Access Compliance Report

Public Rights-of-Way

Intersection ID: 49926	Main Street: CAMPBELL_HALL_CT	Cross Street: WOBURN_RD	Location: NW
ADA ID: E40C7B23E49D	Ramp Type: Perp	Initial Pass/Fail: Fail	Overall Compliance: No
		Severity Score: 12.5

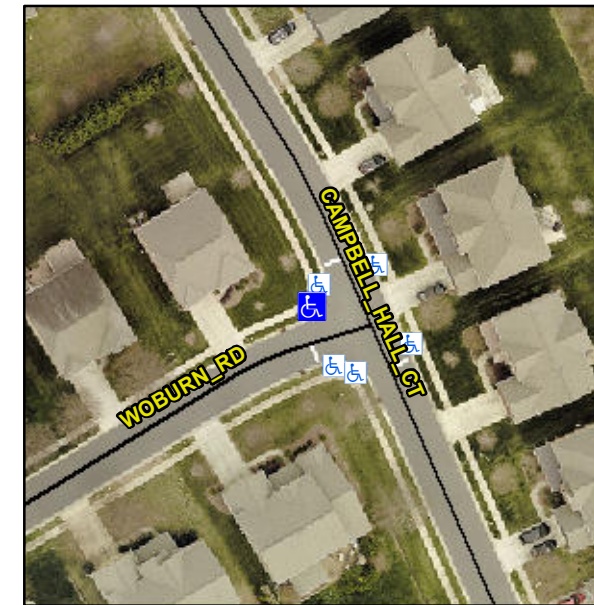
Not Found, R304.2.2

Compliance	Description	Data	Compliance	Description	Data
N/A	Ramp Length (in)	46.0	No	Ramp Slope (%)	8.9
Yes	Ramp Width (in)	48.0	Yes	Ramp XSlope (%)	0.8
N/A	Flare Type LT	N/A	N/A	Flare Type RT	N/A
N/A	Flare Slope LT (%)	N/A	N/A	Flare Slope RT (%)	N/A
N/A	Flare Traversable LT?	N/A	N/A	Flare Traversable RT?	N/A
N/A	Landing Length (in)	N/A	N/A	DWS Provided?	N/A
N/A	Landing Width (in)	N/A	N/A	DWS Contrast?	N/A
N/A	Landing Slope (%)	N/A	N/A	DWS Length (in)	N/A
N/A	Landing X Slope (%)	N/A	N/A	DWS Full Width?	N/A
N/A	Landing Curb? (Y/N)	N/A	N/A	DWS Offset (in)	N/A
N/A	Shared Landing?	N/A			
N/A	Gutter Ponding?	N/A	N/A	Gutter Slope (%)	N/A
N/A	Gutter Lip Ht (in)	N/A	N/A	Gutter X Slope (%)	N/A
N/A	Painted X Walk1?	No	N/A	Painted X Walk2?	N/A
	X Walk 1 Direction	To SE		X Walk 2 Direction	N/A
N/A	X Walk 1 Width (in)	N/A	N/A	X Walk 2 Width (in)	N/A
	X Walk 1 Slope (%)	0.9		X Walk 2 Slope (%)	N/A
	X Walk 1 X Slope (%)	1.0		X Walk 2 X Slope (%)	N/A

Remove & Replace Entire Ramp.
